## CHCC Flooring Replacement Bid Q&A

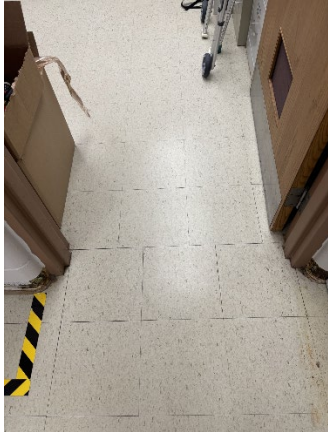
***Photos & Site Conditions: Can the County provide photos showing the space, existing flooring, door thresholds, and transition areas between the PT room, kitchen, office, and adjoining hallways?***

*Office*

*Hallway*

*Kitchen*
